Low Temp Test procedure for EVs and pure ICE vehicles

**Open topics to be discussed and concluded until March 4th
Revision 4**

Status: 26.02.2020

Test Procedure (NOVC-HEV and pure ICE vehicles) – Test Proposal for -7°C Procedure

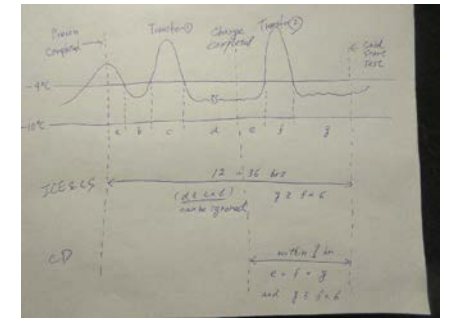
First soak can be omitted as a manufacturers option.
 EC does not support to provide this option
 JPN supports to provide this option; if EC is not able to supported this option, JPN's position is to strike out first soak completely
 → Discussion and conclusion

Two positions:
 JPN: allow precon at 23°C as manufacturers option
 EC: precon @-7°C
 → Discussion and conclusion

Forced cool down
 → see Open Topic list
 → Discussion and conclusion

Vehicle outside the temperature tolerance (-7±3) during the transfer from soak to dyno for time "f":
 Additional soak time "g" on the dyno is required before the start of the cold start test which is calculated as follows: $g \geq 6 * f$
 → Discussion and conclusion

EC requires facility modification according to last week comments on 4WD dyno
 → Discussion and conclusion

Input JPN
 → Discussion and conclusion

1 Leaving soak (-7°C) until starting test in test cell (-7/23°C): max.: [40] min (transfer: max. [20] min, preparation on dyno: max. [20] min)
 → Without any unjustified delay; vehicle shall not receive unjustified exposure to temperatures higher than -7°C; in case that is unavoidable, this shall not be longer than [20] min
 → Note: only max. [30] min between different tests on the dyno shall not be exceeded (only related to dyno warm-up)

Test Procedure (OVC-HEV) – Charge Depleting Test

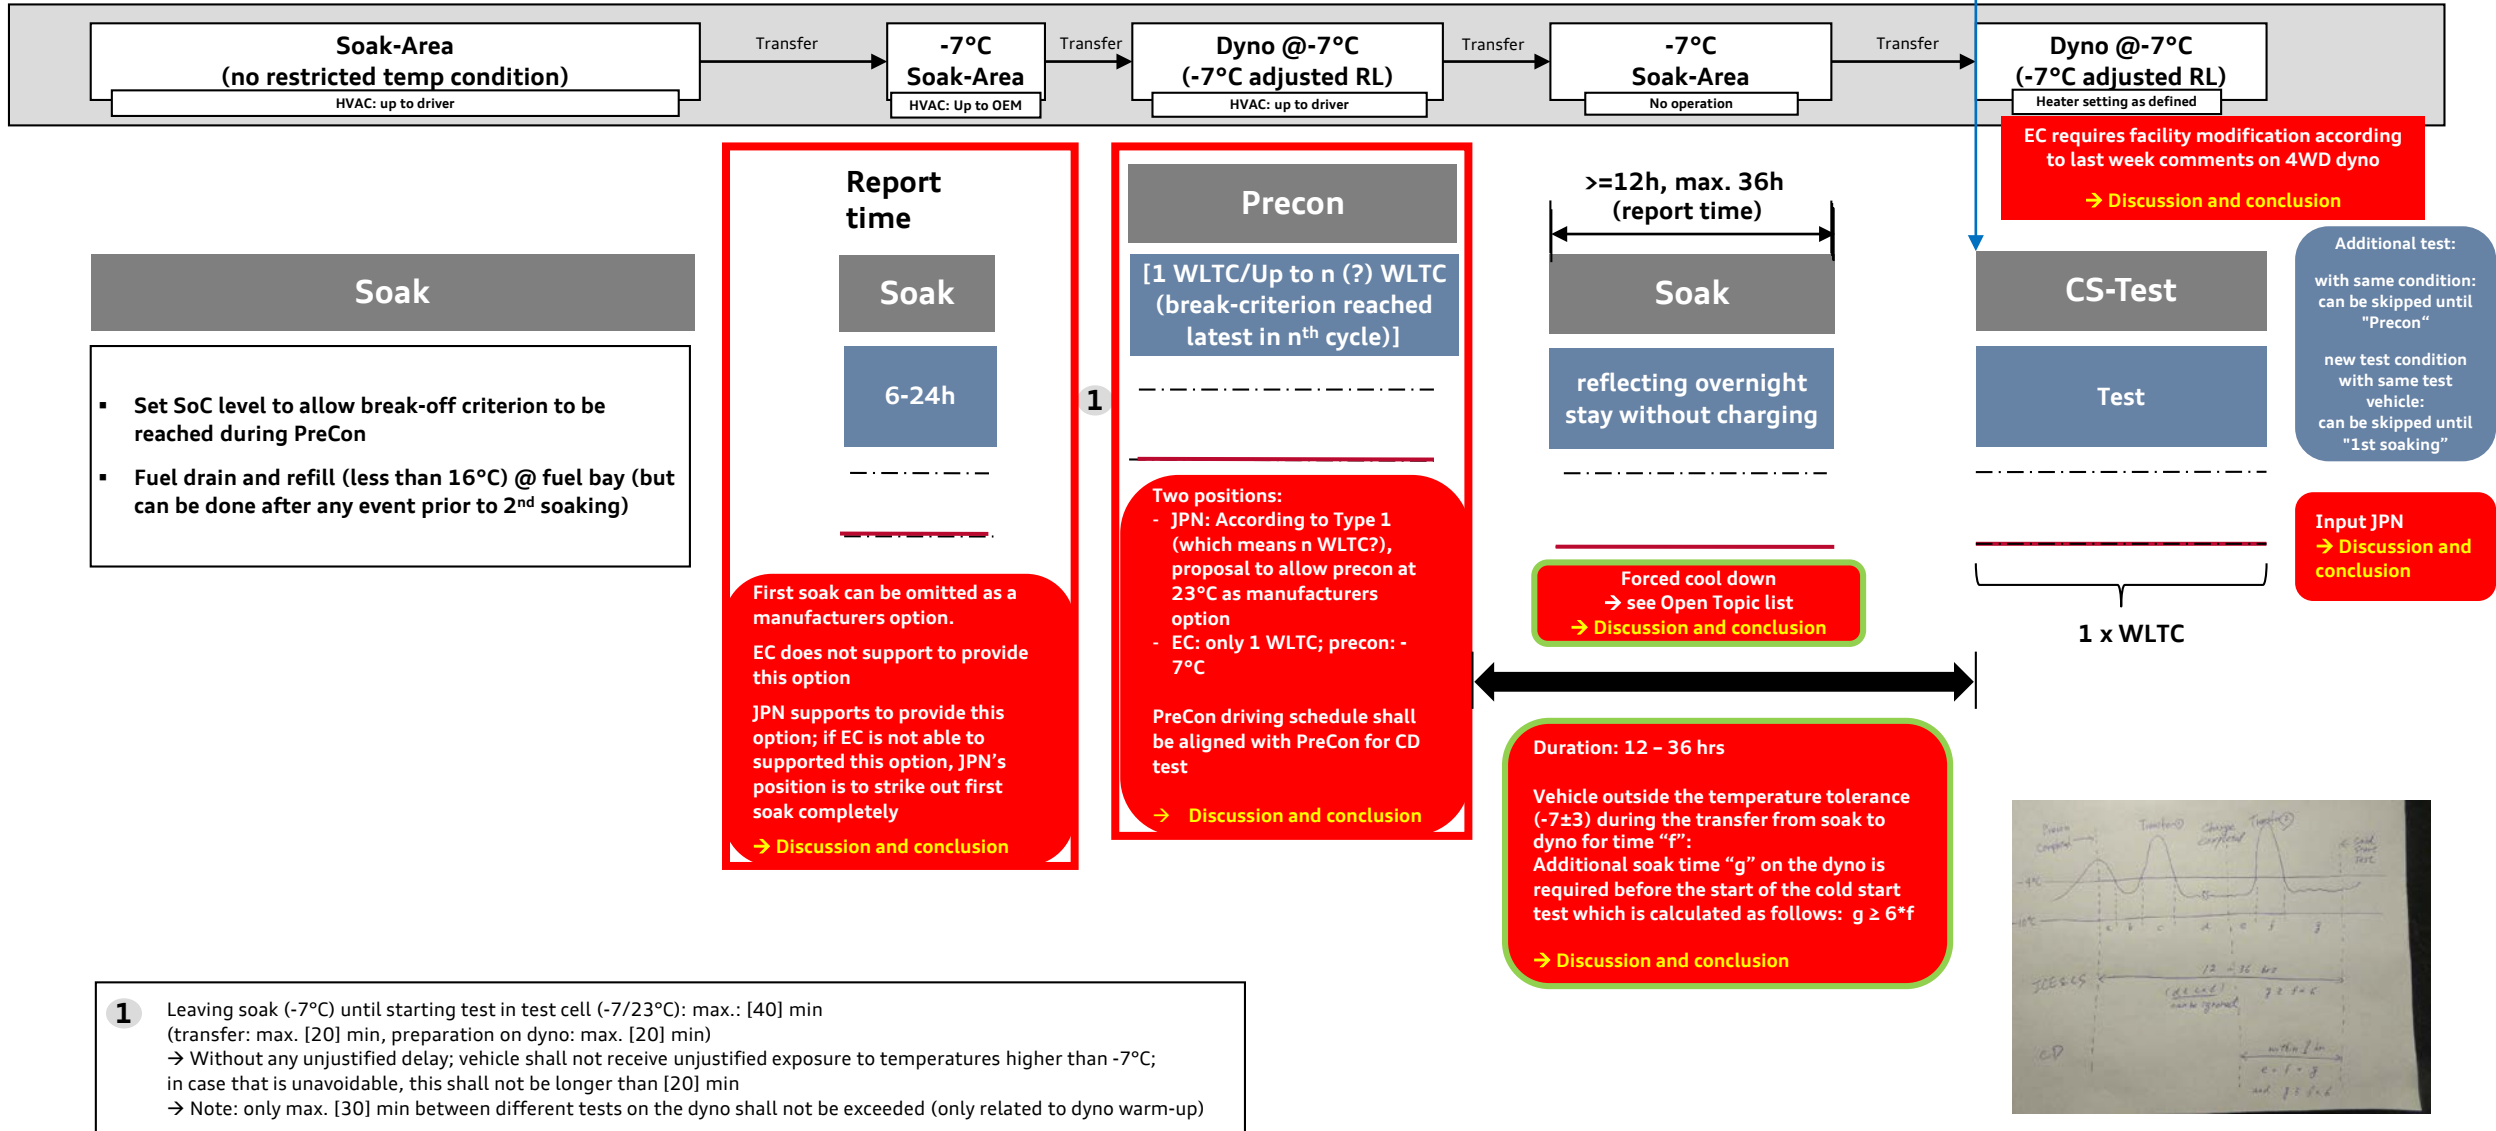
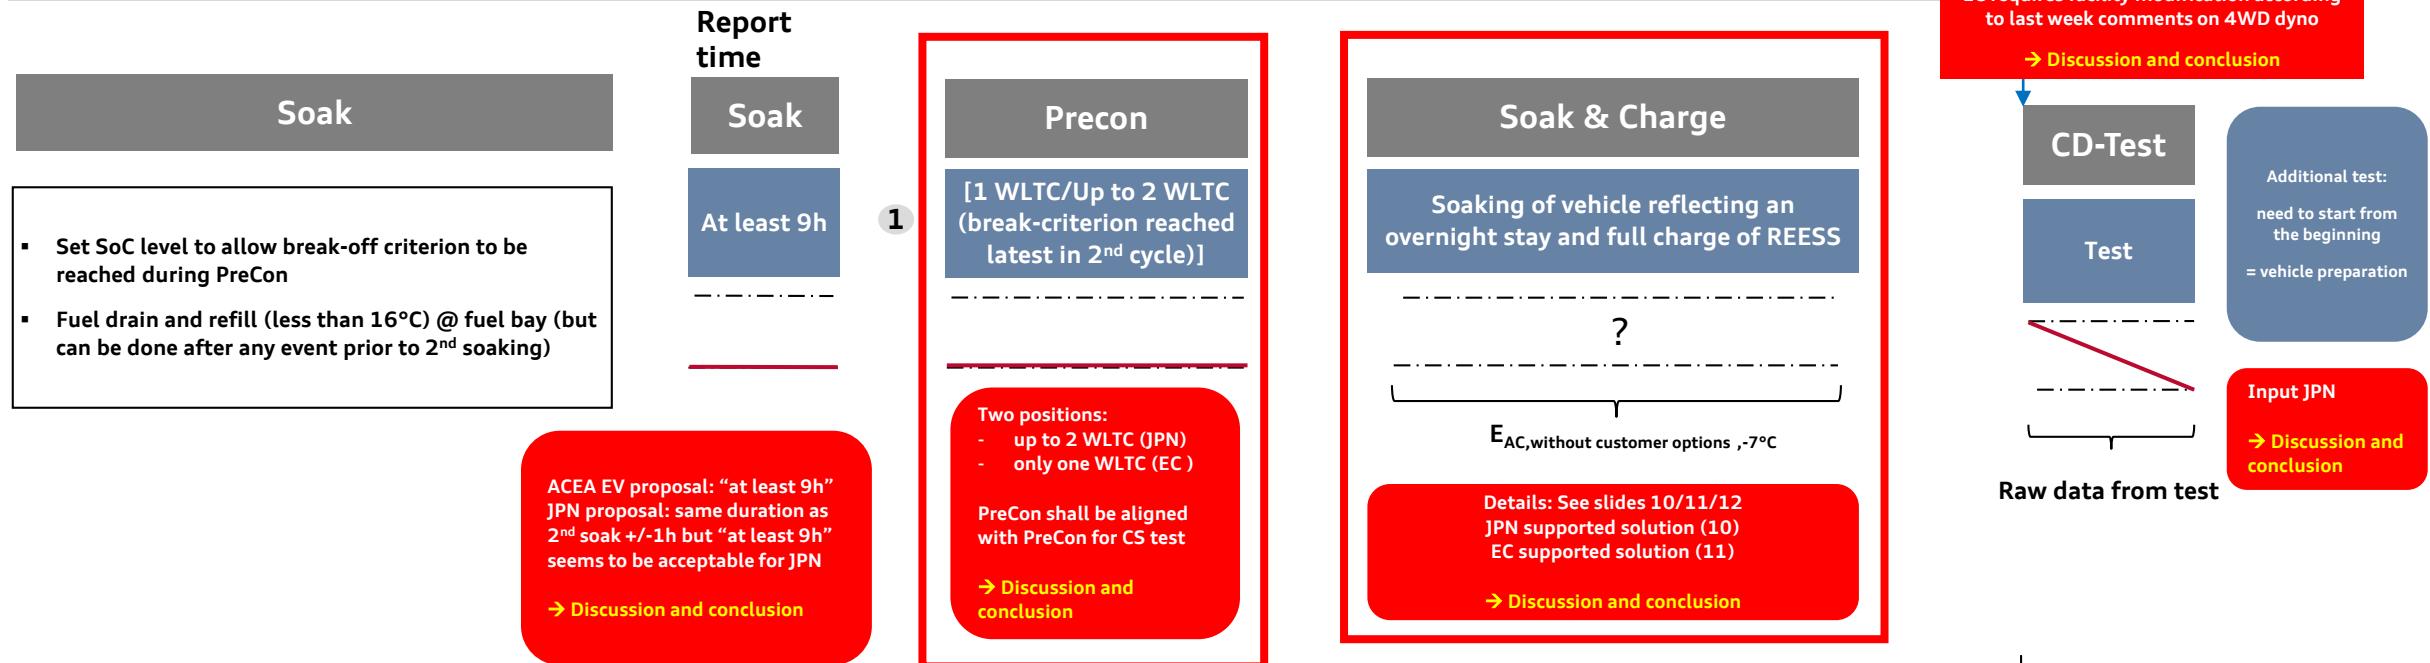
ACEA EV proposal: "at least 9h"
JPN proposal: same duration as 2nd soak +/-1h but "at least 9h" seems to be acceptable for JPN

- up to 2 WLTC (JPN)
- only one WLTC (EC)

PreCon shall be aligned with PreCon for CS test

Duration: 12 – 36 hrs
Time between charge completed and cold start test: < 1h

At the option of the manufacturer:
Vehicle outside the temperature tolerance (-7±3) during the transfer from soak to dyno for time "f":
An additional soak time "g" on the dyno is required before the cold start test which is calculated as follows: $g \geq 6 \cdot f$

1 Leaving soak (-7°C) until starting test in test cell (-7/23°C): max.: [40] min
(transfer: max. [20] min, preparation on dyno: max. [20] min)
→ Without any unjustified delay; vehicle shall not receive unjustified exposure to temperatures higher than -7°C; in case that is unavoidable, this shall not be longer than [20] min
→ Note: only max. [30] min between different tests on the dyno shall not be exceeded (only related to dyno warm-up)

Test Procedure (PEV and CD-test of OVC-HEVs) – Second Soak with Charge

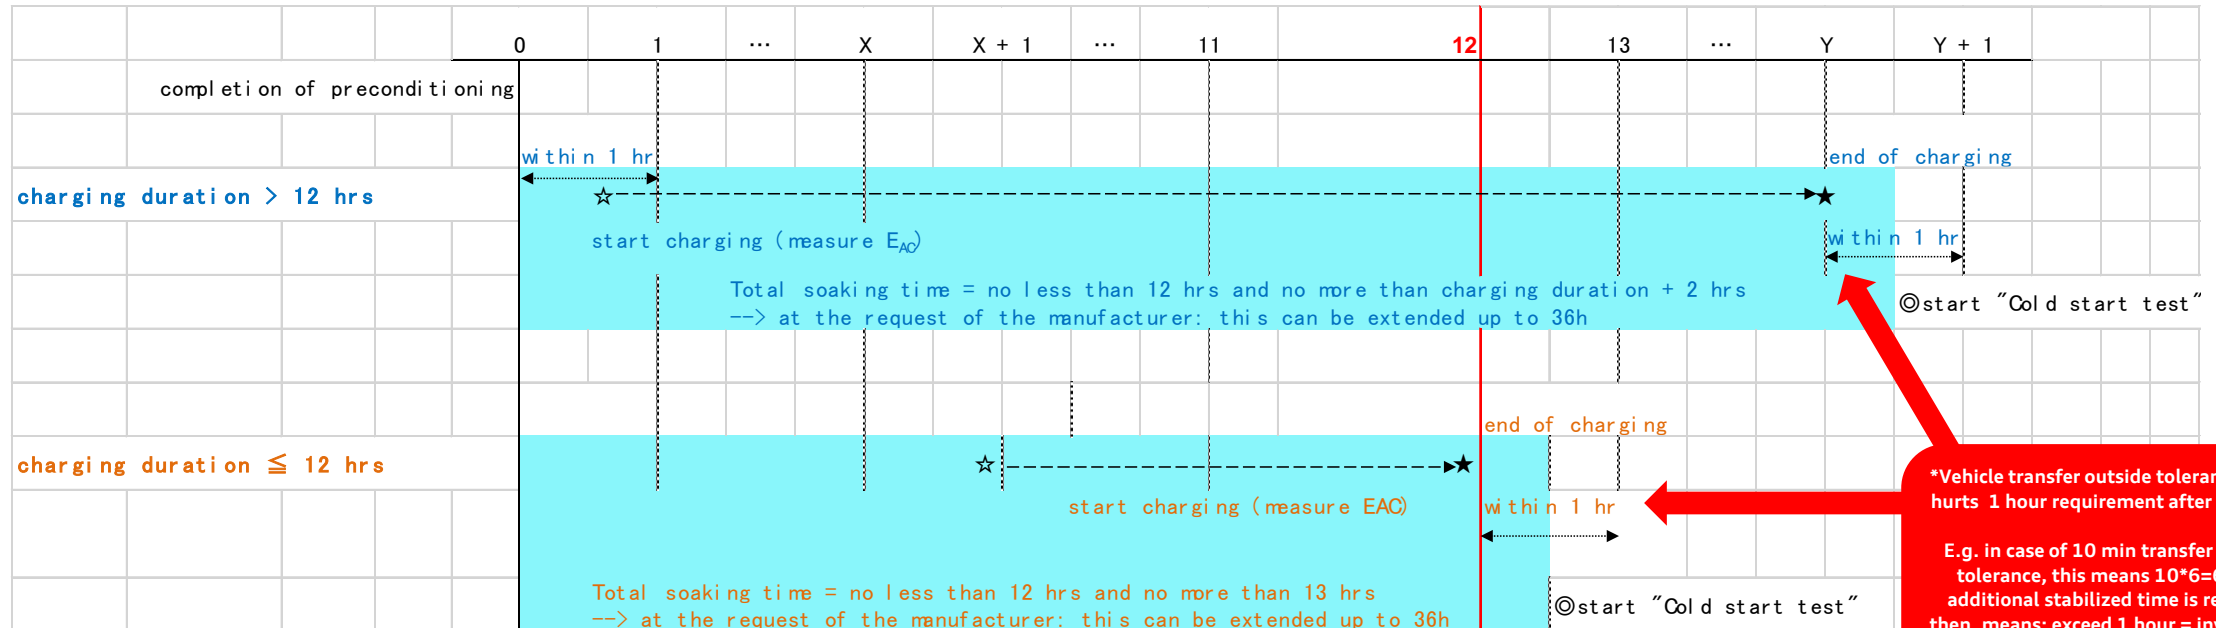
- End of charging shall correspond with end of second soak
- Soak time of 12h which need to be extended if charging is not finished after 12h until the point in time charging is finished
At request of manufacturer, the resulting charging time of 12h (or more if charging not finished) can be extended up to 36h
- If charging time < soaking time, start of charging shall be delayed → so end of charging corresponds to end of second soak
- Test start after end of soak/end of charging (which means de-plugging of vehicle from the grid) within 1h*

*Vehicle transfer outside tolerance (-7 ± 3) hurts 1 hour requirement after soak end.

E.g. in case of 10 min transfer outside tolerance, this means $10 \times 6 = 60$ min additional stabilized time is required. then, means: exceed 1 hour = invalid test.

→ Needs further consideration

Test Procedure (PEV and CD-test of OVC-HEVs) – Second Soak with Charge

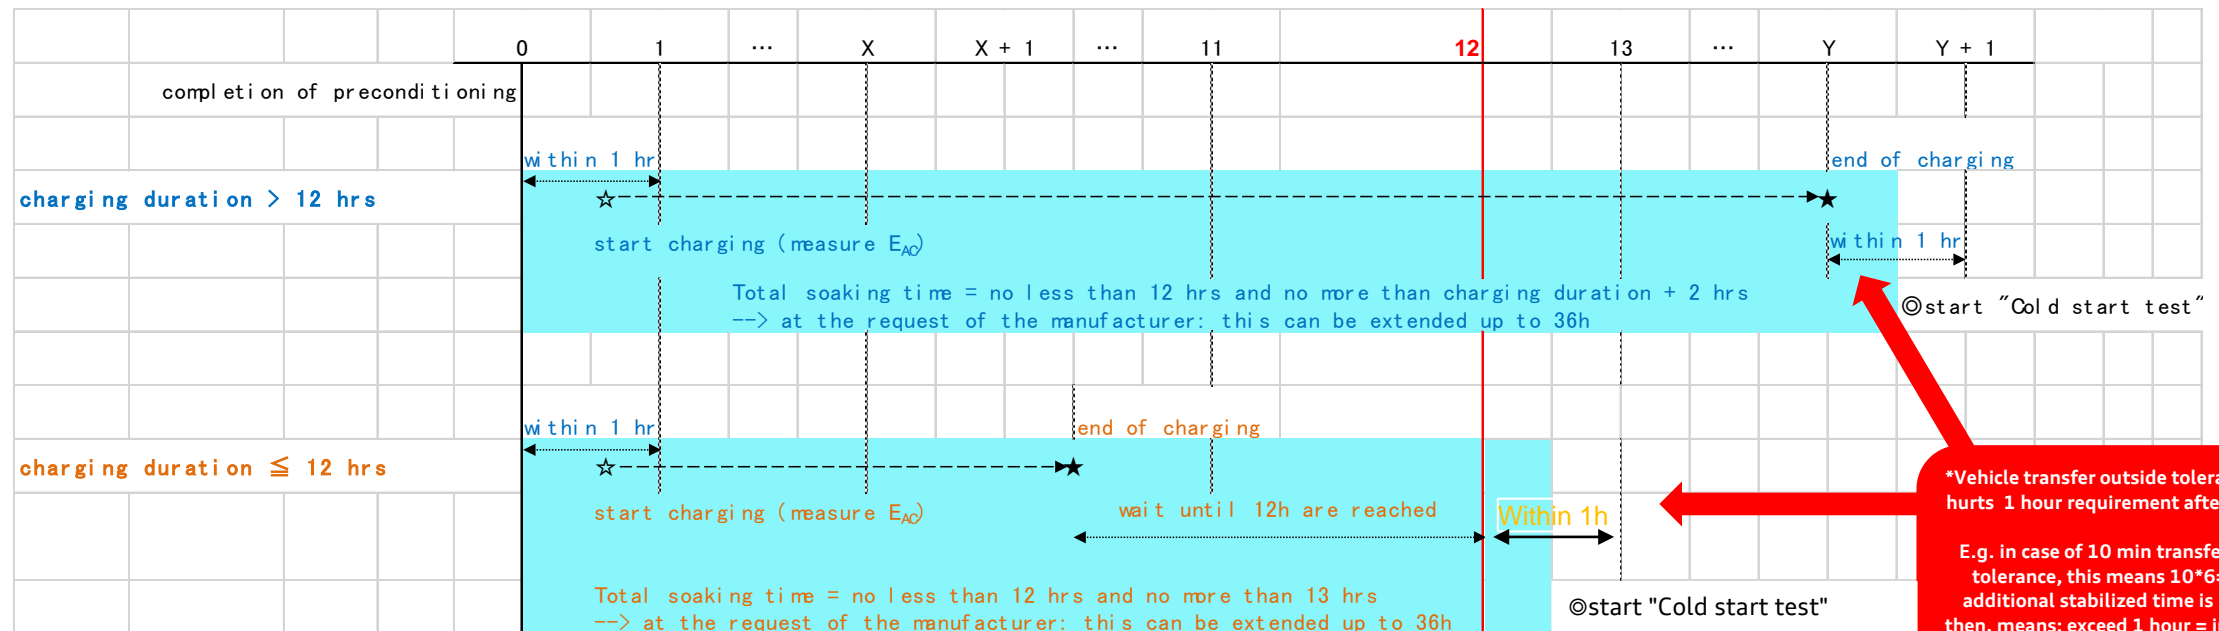
- Start of Charging with start of second soak
- Soak time of 12h which need to be extended if charging is not finished after 12h until the point in time charging is finished
At request of manufacturer, the resulting charging time of 12h (or more if charging not finished) can be extended up to 36h
- Test start after end of soak (which means de-plugging of vehicle from the grid) within 1h*

*Vehicle transfer outside tolerance (-7±3) hurts 1 hour requirement after soak end.

E.g. in case of 10 min transfer outside tolerance, this means 10*6=60 min additional stabilized time is required. then, means: exceed 1 hour = invalid test.

→ Needs further consideration

Test Procedure (BEV) – comparison between CCP, STP and SSTP

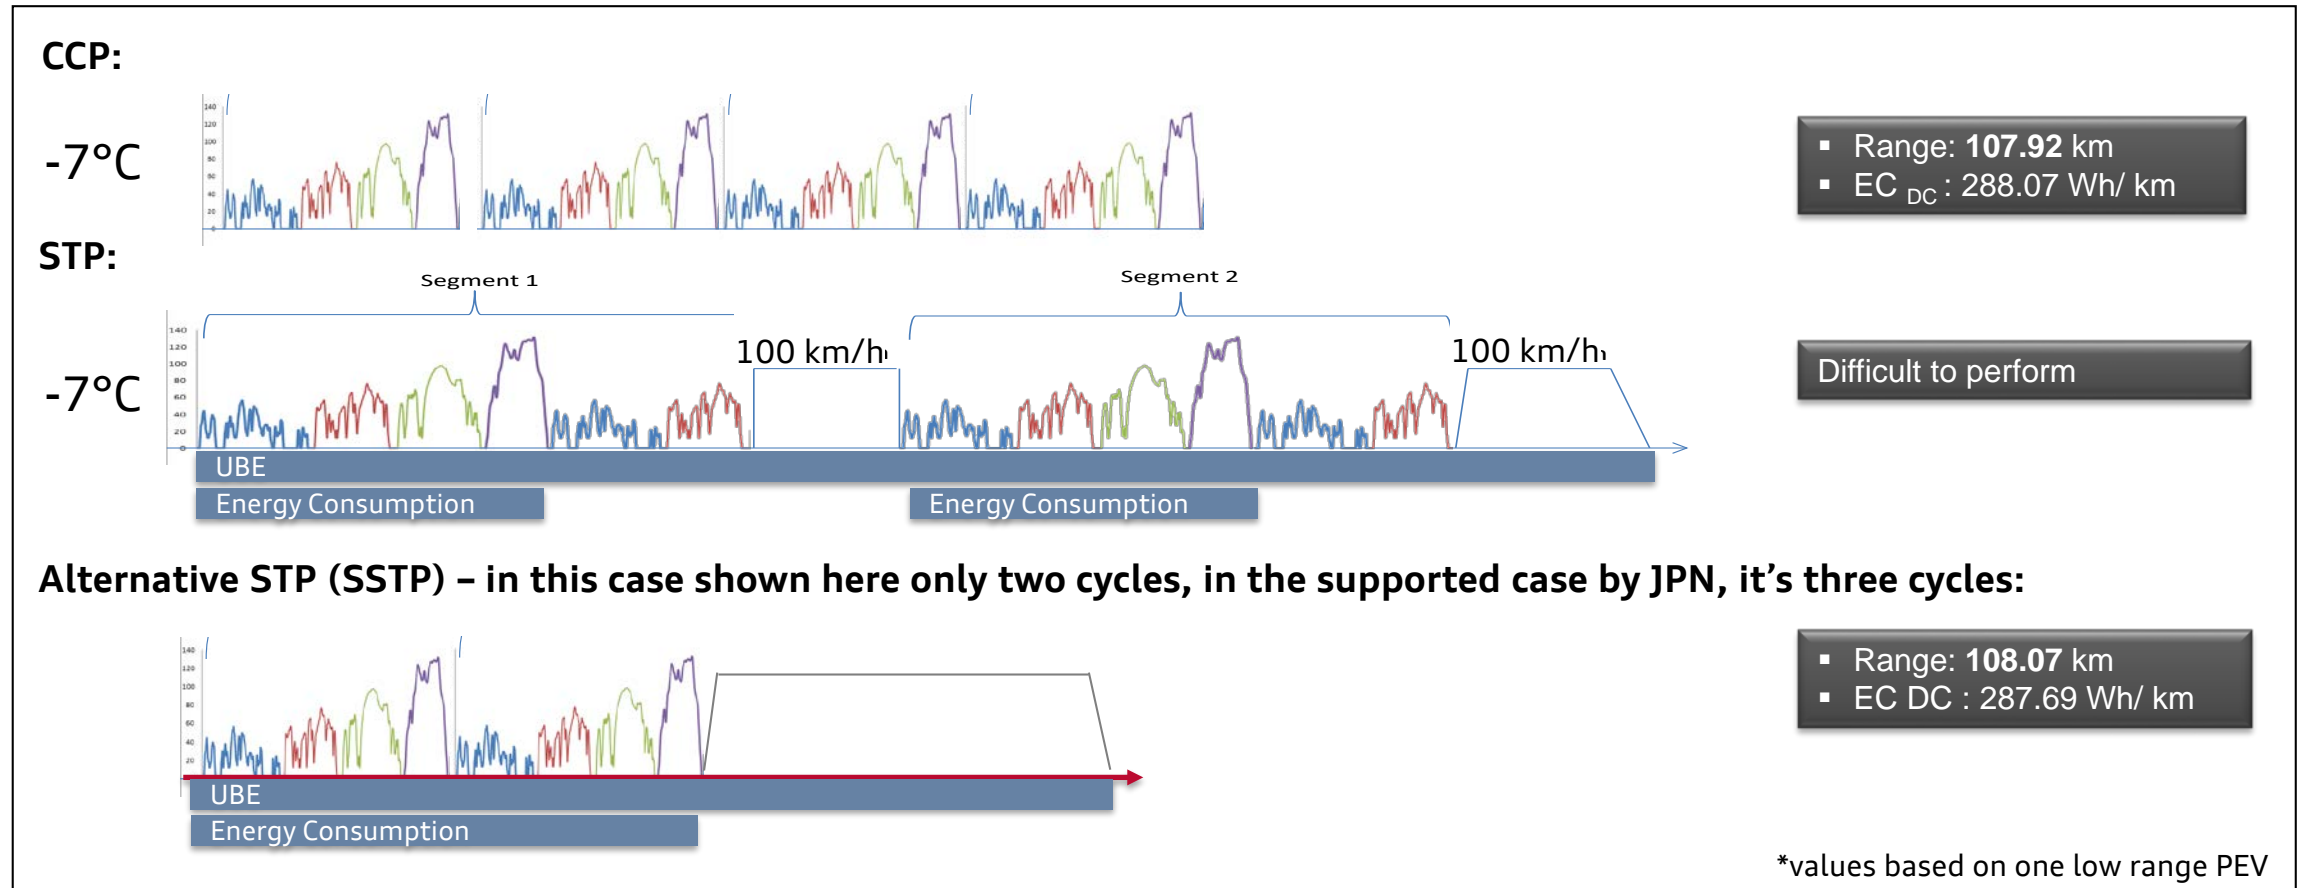
- STP might be difficult to perform at -7°C (even if done at 23°C) due to the higher electric energy consumption
- To avoid the situation to run into problems, proposal is to drive the dynamic segments at the beginning and the constant speed segments in 1 piece at the end → UBE can be measured at -7°C
